Project	IEEE 802.16 Broadband Wireless Access Working Group http://ieee802.org/16 >
Title	In-band Transparent Relay Frame Structure
Date Submitted	2006-04-04
Source(s)	Kanchei (Ken) Loa, Yi-Hsueh Tsai, Yung-Ting Lee, Heng-Iang Hsu Shiann-Tsong Sheu, Frank C.D. Tsai, Youn-Tai Lee, Chih-Chiang Hsieh, Hua-Chiang Yin, Institute for Information Industry 8F., No. 218, Sec. 2, Dunhua S. Rd., Taipei City, Taiwan.
	Gang Shen, Kaibin Zhang gang.a.shen@alcatel-sbell.com.cn Alcatel-Lucent, Research & Innovation 388#, Ningqiao Road, Shanghai, China.
	[add co-authors here]
Re:	IEEE 802.16j-07/013: "Call for Technical Comments Regarding IEEE Project 802.16j"
Abstract	This contribution proposes in-band transparent relay frame structure
Purpose	Text proposal for 802.16j Baseline Document
Notice	This document has been prepared to assist IEEE 802.16. It is offered as a basis for discussion and is not binding on the contributing individual(s) or organization(s). The material in this document is subject to change in form and content after further study. The contributor(s) reserve(s) the right to add, amend or withdraw material contained herein.

In-band Transparent Relay Frame Structure

This contribut

Figure yyy Example of configuration for an in-band transparent relay frame structure

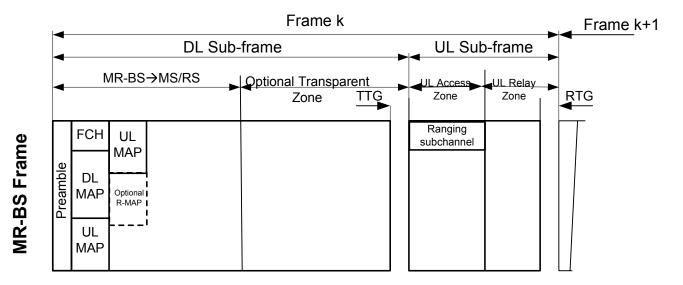
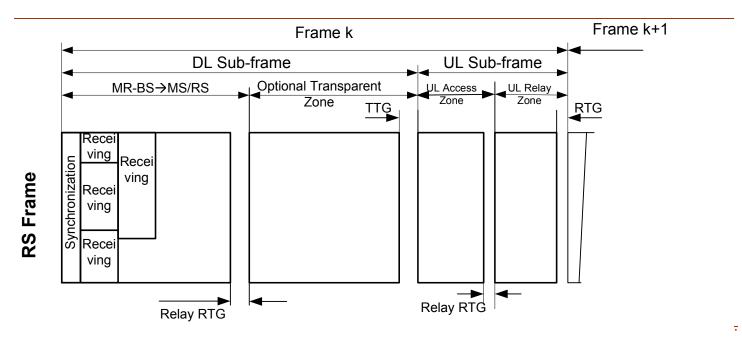
[Change the figure in section 8.4.4.7.1 "Frame structure for transparent mode" as indicated:]

[Replace Figure xxx with Figure yyy as follows:]
